MI&CT eSERVICE NOTE

SN08100112a

Subject: Keyboard and SCIM Deviation for GOC6 Operator Console

Effectivity: GOC6 Consoles (see below)

Beige Keyboards

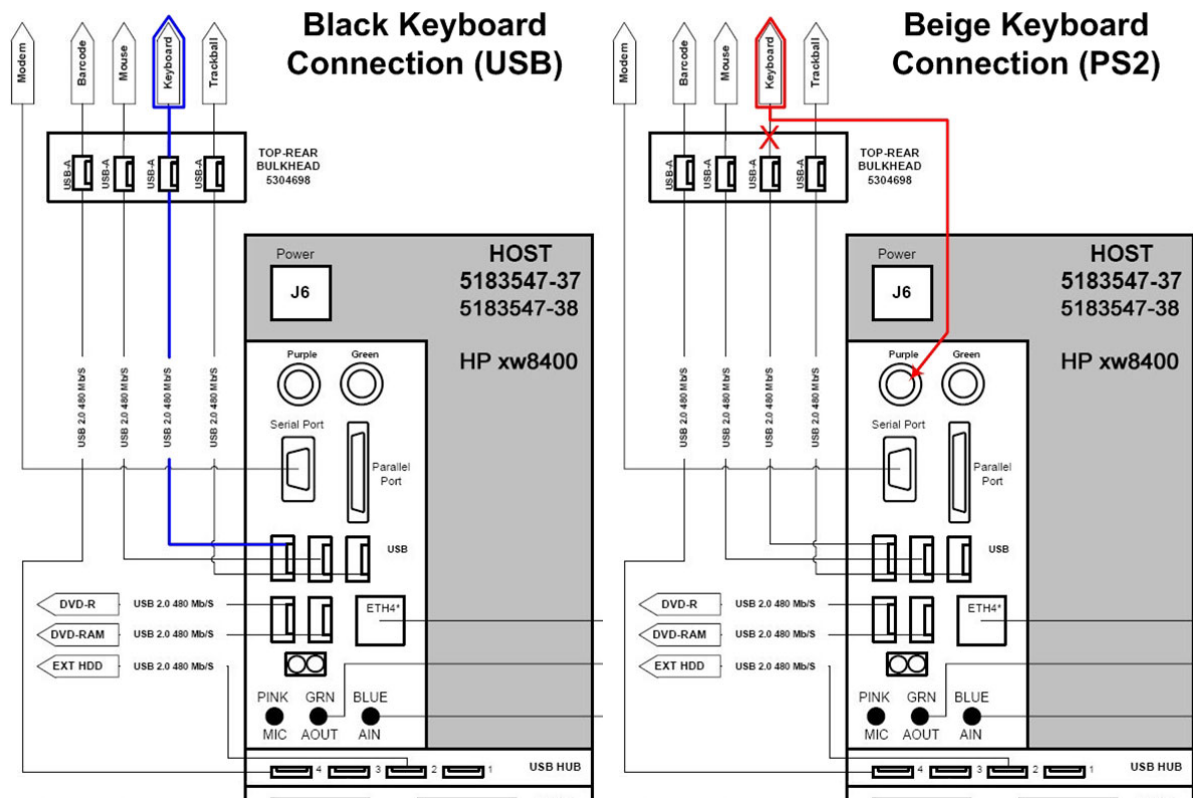
Due to Supply Chain issues, the new GOC6 Console will not have the black colored SCIM and Keyboards as per design. Instead the new console will be supplied with existing beige colored SCIM and Keyboards. Anticipated arrival of the black colored SCIM and Keyboards is 1st quarter 2009.

Consequently there is Service Documentation impact related to the use of the beige colored SCIM and Keyboards with the GOC6 Console. FRU part numbers and console keyboard installation are affected. *(Note: Beige colored SCIM installs the same as the black colored version on GOC6.)*

The beige colored keyboards utilize a PS2 interface, verses the newer USB interface. With design changes implemented in the GOC6 Console, support for the older PS2 keyboard connector is no longer present on the Upper Bulkhead Panel connector. Consequently, the beige colored keyboards must be connected directly to the Host PC's PS2 Keyboard Port inside the GOC6 console. When installing the beige colored keyboards, follow the connection process below. Do not follow the instructions in the GOC6 Service Manuals. These procedures are for the new USB connected black keyboards.

When using the beige colored PS2 style keyboards, connect the keyboard directly to the Host Computer's Purple PS2 Port on the rear of the HP xw8400 PC. See Illustration below.

Pass the keyboard cable along the Upper Rear Bulkhead panel at the top of the console cabinet and behind the console's rear cover assembly, along with the Monitor Video and DVD Peripheral Tower USB cables.
